## Major Comments:

1. **DEC Comment: Ribbed Mussels.** [Note: The overall text of DEC's comment on Ribbed Mussels contains a number of specific points to which DEP has responded below. The specific points in DEC's comment, as identified by DEP, are highlighted in the text below, and provided with a superscript letter that keys to the specific DEP response.] Under the selected alternative, the City has proposed construction of ribbed mussel beds in both Bergen and Thurston Basins to reduce bacterial load from CSOs and storm water discharges to these waterbodies. Ribbed mussels have not been considered under any other LTCP and represent a novel yet unproven technology. The ribbed mussel beds are the primary component of the selected alternative that will be used to reduce bacterial loads to both Basins (the other components have no or negligible impact on water quality) and the analysis presented in Appendix D assumes that the ribbed mussels will remove 10 percent of the bacterial load in the waterbodies. Based on that assumption, attainment levels in the Basins for the fecal coliform water quality standard will improve by up to 5 percent on an annual and recreational season basis.

**Figure 7 – JAM-005/007 In-line Storage Alternative**

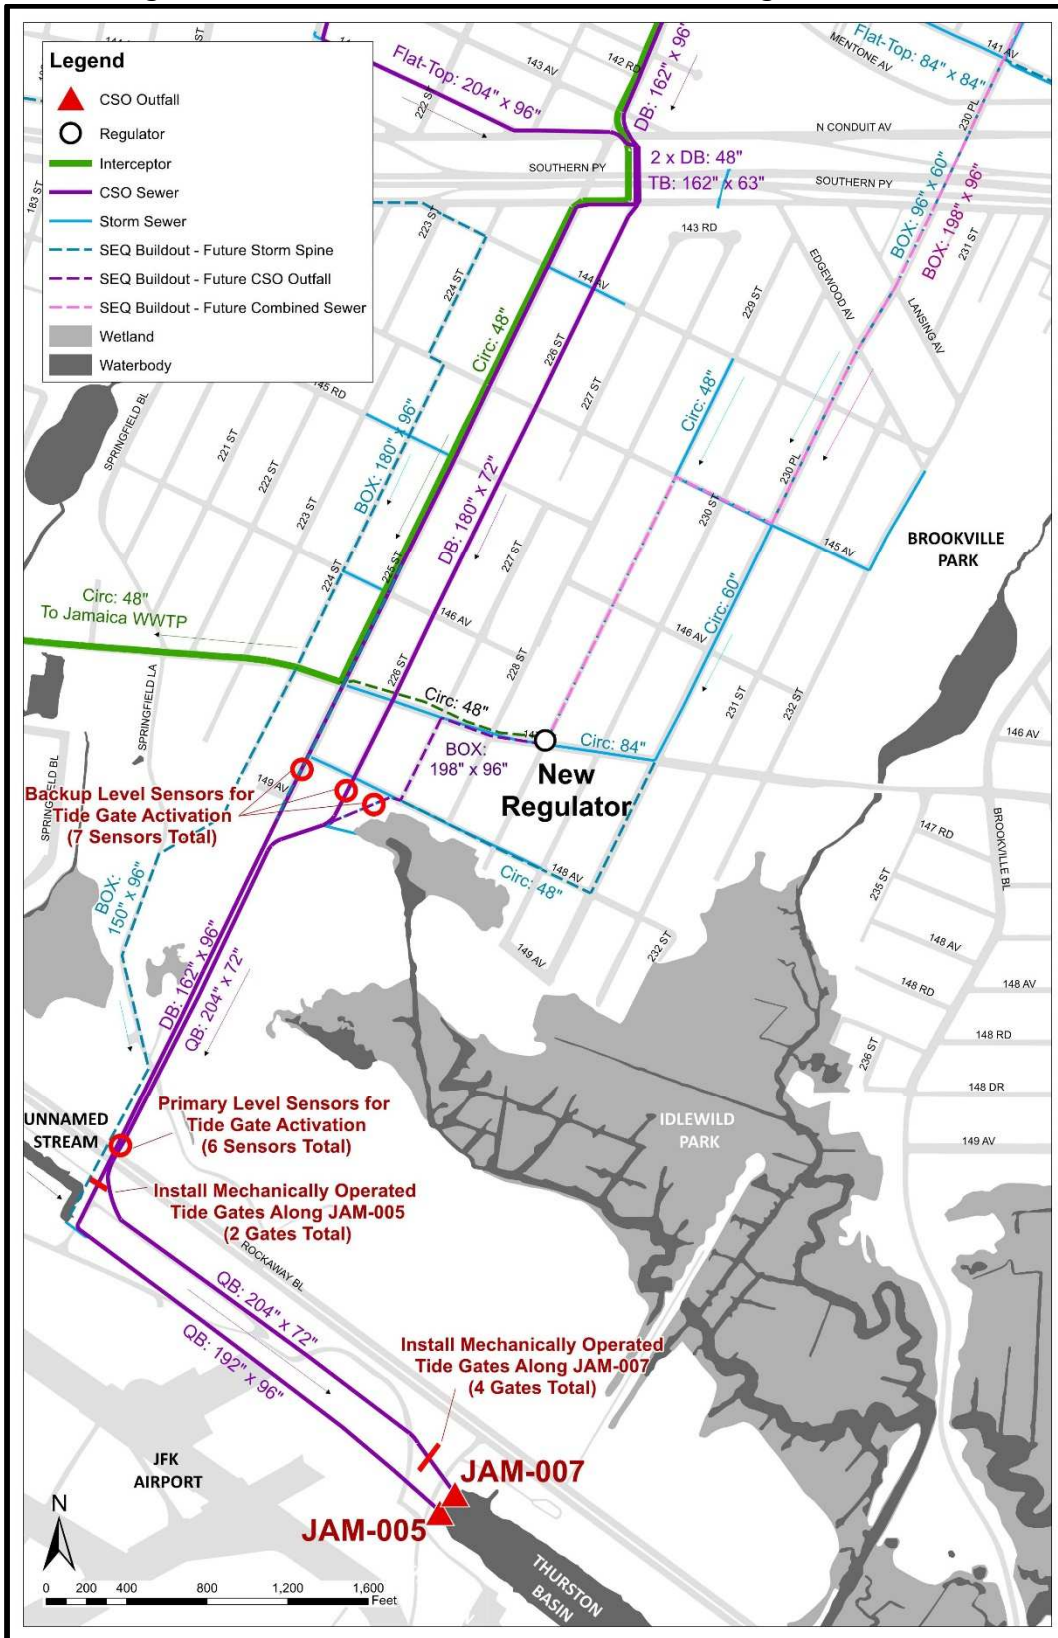
- d. **DEC Comment: In-Line Storage.** The City evaluated in-line storage to reduce CSOs to Bergen and Thurston Basins, but eliminated this alternative for various technical reasons. However, for Thurston Basin, the City must consider installation of tide gates to reduce the tidal influence for these outfalls for the in-line storage option.

**DEP Response:** *Installation of gates would be required at multiple locations as indicated in **Figure 7** to isolate tidal inflow from Thurston Basin, as well as an existing unnamed stream that connects to Outfall JAM-005 approximately 2200 feet upstream of the outfall discharge. The gates would be located at the discharge end of each of the four barrels of JAM-007 and on two outfall sewer barrels of JAM-005 just upstream of the connection of the unnamed stream as shown in **Figure 7**. The gates on JAM-005 are necessary to prevent backflow of the stream along the outfall which would reduce in-line storage capacity during high tide conditions and increase the risk of deposition of debris and sediment. Deposition of stream debris within the outfall will also increase the risk of clogging the dewatering pumps and reduce storage and conveyance capacity.*
